**Reclamation Board Meeting
June 16, 2006**

**Staff Report
Encroachment Application No. 18018-2
Califia, LLC (River Islands at Lathrop)**

**Request for Encroachments on Fill Placed On and Adjacent to Project Levees
San Joaquin River, Reclamation District No. 2062, City of Lathrop**

Figure 3

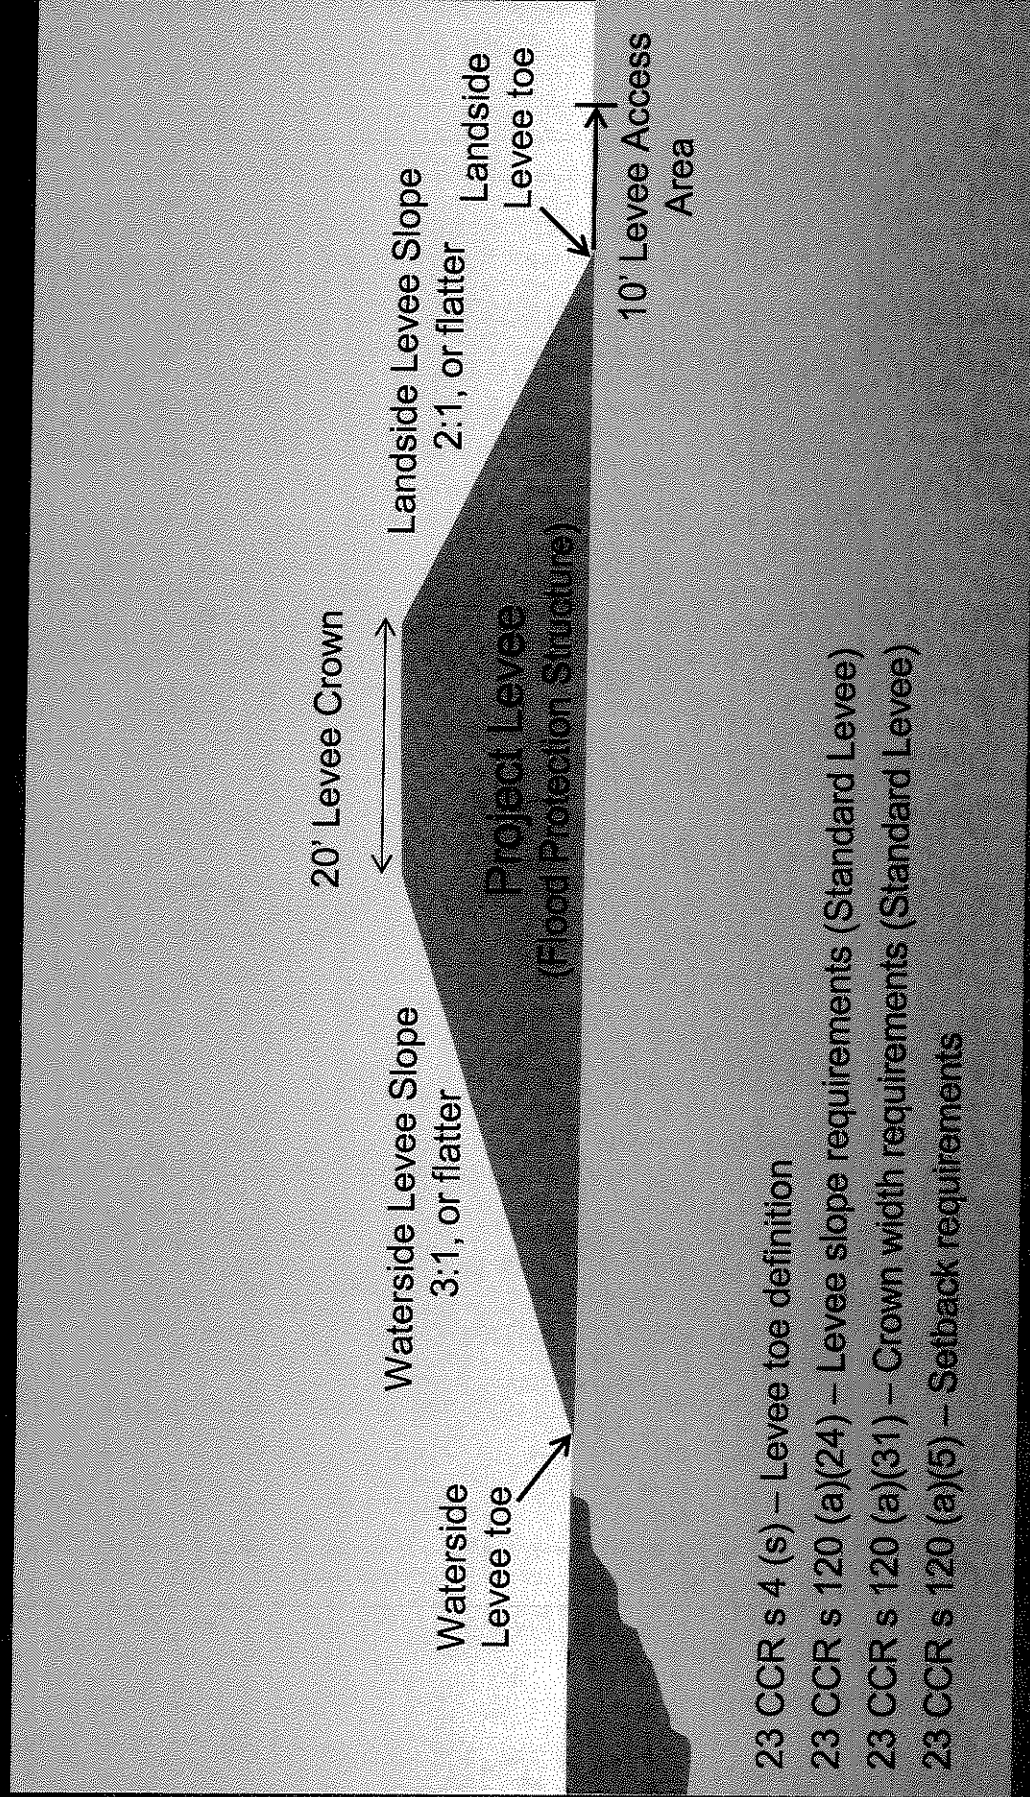
The River Islands at Lathrop Project levee design and easement proposal is discussed in the following paragraphs. The minimum levee cross-section and design parameters being proposed for project levees that are being constructed or reconstructed on RD-2062 as part of River Islands is shown on Figure 3 and the proposed project levee easement area, which has been subdivided into Zone A and Zone B, to be provided to the Board is shown on Figure 4.

The finished slope of any project levee constructed or reconstructed and any levee constructed that is expected by the applicant to be requested to become a project levee must be three (3) feet horizontal to one (1) foot vertical, or flatter, on the waterside and two (2) feet horizontal to one (1) foot vertical, or flatter, on the landside. Under Title 23, Section 4 (s), the levee toe is defined as the point of intersection of the levee slope with natural ground. The landside slope will end at the landside toe. The location of the waterside and landside toes will be as determined by Board staff.

The crown width of any project levee constructed or reconstructed and any levee that is expected by the applicant to be requested to become a project levee must be a minimum of 20 feet, as described for a standard sized levee section in Title 23, Section 120 . The minimum allowable levee crown elevation is to be based on the lesser of the elevations shown on the Corps of Engineers Levee Profiles for the San Joaquin River and Tributaries Project dated December 23, 1955 or as modified and shown on "as-built" drawings submitted subsequent to December 23, 1955 (Corps Profile) or the water surface elevation as computed for the 200-year hydraulic analysis performed by MBK Engineers and identified as the "Overtopping with No Failure" analysis (MBK Study). The maximum crown elevation of any project levee constructed or reconstructed and any levee that is expected by the applicant to be requested to become a project levee is to the Corps Profile.

The 10-foot levee access area located landward of the landside levee toe, as shown on both Figure 3 and Figure 4, is required by Title 23, Section 120(a)(5) as discussed above. This space is required for control of encroachments that could affect the integrity of the levee and for access to the buried levee section and foundation area for equipment operation and construction activities. This area is an integral part of any levee easement and is included as part of Zone A, the levee easement area, as required by Title 23.

Figure 4

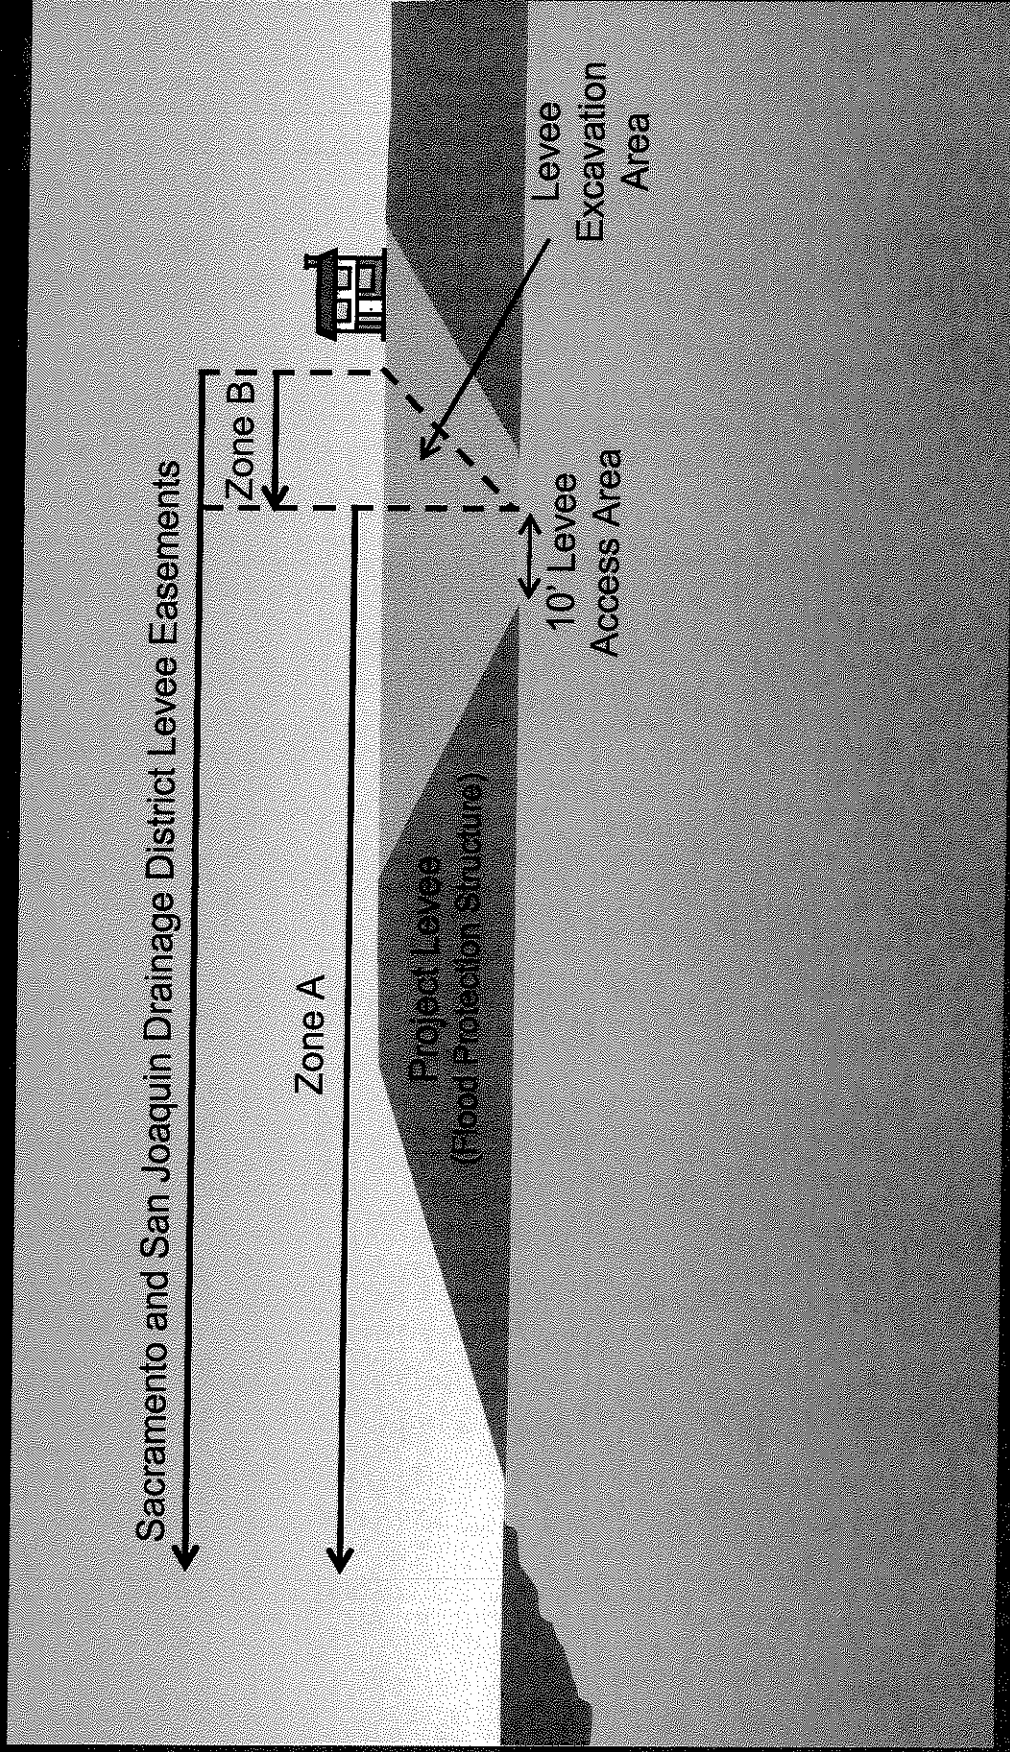
Zone A, the levee easement area, as shown on Figure 4 consists of all property owned located waterward of the landward boundary of the levee access area. The area defined by Zone A will have a standard Reclamation Board levee easement that allows for construction, reconstruction, operation, maintenance, and inspection of project facilities and all proposed encroachments or activities in this area that are not addressed by this permit, if approved by the Board, will require an approved Board encroachment permit. Private, individual encroachments will not generally to be permitted within Zone A. Generally, most if not all of Zone A is expected to designated as communal property for use as park/open space where the designated use is consistent with the Zone A primary purpose of protecting a federal flood facility.

Zone B, the excavation easement, will apply to the area located landward of Zone A a distance equal to the depth of the fill material along the landward Zone A boundary and slope excavation criteria established by the California Occupational Safety and Health Administration (Cal OSHA) based on the soil parameters of the engineered fill material. The Zone B area required in order to safely excavate for access to the project levee easement area as defined by Zone A. Zone B is expected to consist primarily of individual, private residential parcels and, in general, Reclamation Board permits will not be

As a condition of this and future associated permits, if approved by the Board, the applicant and/or RD-2062 will be required to provide an easement for all lands owned by either entity within area as defined by both Zone A and Zone B. The easement will physically describe the location of the boundary between Zone A and Zone B and clearly state the purpose and use of each zone. In exchange for clear title to the above easements, the Board is expected to quit-claim the hodge-podge of existing easements within RD-2062 (Figure 5).

River Islands Levee Easement

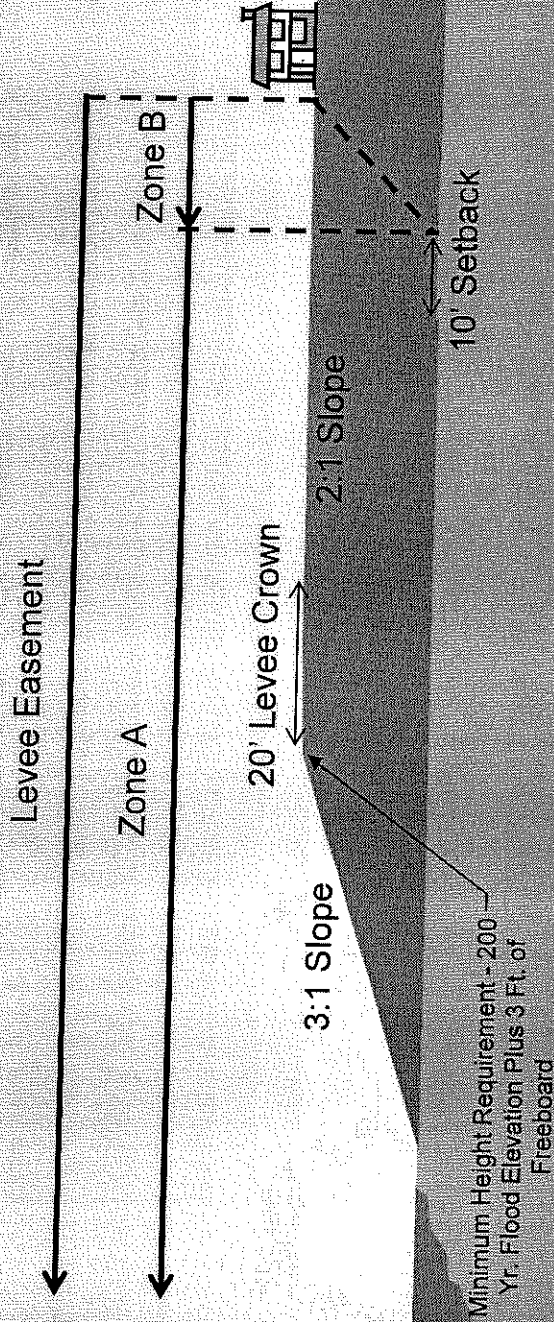
In accordance with our discussion today with you and Scott Morgan, we agree to modify Applications #18018 and #18023 as shown on the enclosed diagram labeled "River Islands Levee Easement." Please accept this letter as our formal request for these modifications.
